Western Star
Service Bulletin

31-013

Fifth Wheel Outboard Angle Mount Fastener Change

Fig. 1, New High Friction Nut

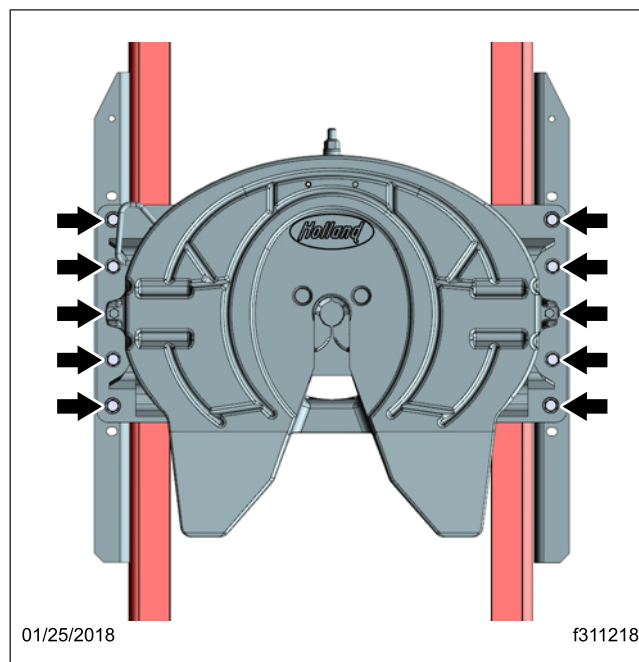
With the start of production on March 6, 2018, the fasteners used to attach the slide- and plate-mount style fifth wheels to the outboard angles changed to M16 metric bolts, nuts, and washers. This change also includes a revision to a higher friction nut which requires an increase in tightening torque. The new higher friction nut can be identified by its blue color (**Fig. 1**). Blue fasteners are metric. If the fifth wheel mounting hardware is being removed replace with new hardware per the part numbers in PartsPro. See **Fig. 2**.

Tighten the fifth wheel M16 fasteners from the bolt head to 170 ± 12 lbf-ft (230 ± 16 N-m).
